RE: CITATION NO. 03-11-17C-014, Source Flow Meter

Citation No. 03-11-17C-014

CITATION FOR VIOLATION OF
CALIFORNIA CODE OF REGULATIONS, TITLE 22, SECTION 64561
Source Flow Meters

Engineering Report
For the Consideration of a Revised Permit for
Westside Grocery Water System
System No. 2400326
Merced County
August 2015

Inspection Photos
Westside Grocery Water System
System No. 2400326
May 5, 2014

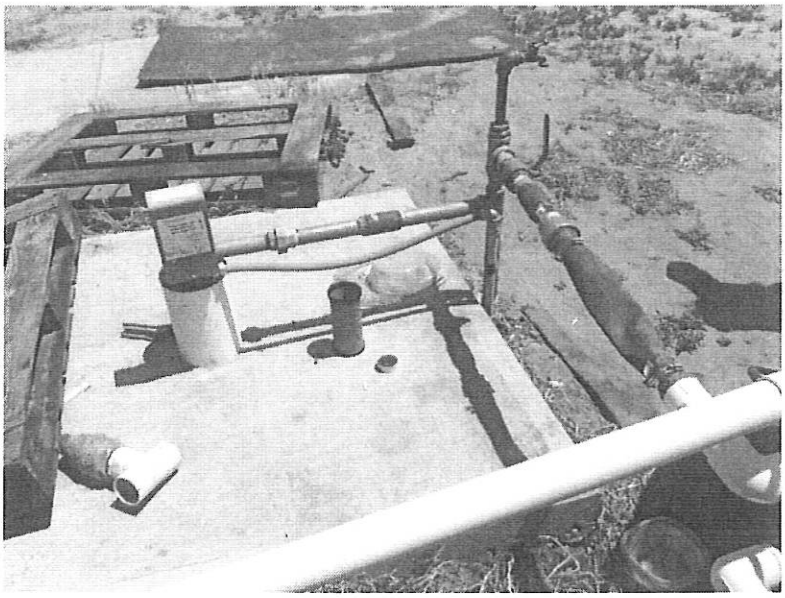
Picture No. 1: The sole source of supply for the Westside Grocery Water System is a well that is located at the back of the property near one of the houses. The well discharge piping features a check valve and a hose bib and a portion of the discharge piping, prior to entering the bladder tank, is flexible. The section of flexible pipe on the irrigation discharge line that goes into the bladder tank, needs to be replaced with a more durable pipe material, such as PVC. In addition, an air vacuum breaker needs to be installed on the hosebib to protect against potential cross connections

Picture No. 2: The discharge piping from the well is directly fed into the domestic water supply system which serves the two residential connections in addition to the convenience store/hot grill. In addition, the well has a second discharge line that goes through a bladder tank and then discharges to a section of flexible pipe that provides irrigation water for the nearby field. The irrigation discharge line is not adequately protected against potential cross-connections and the System must install an RP device to ensure that the domestic water supply system is adequately protected against a potential cross connection from the irrigation system.
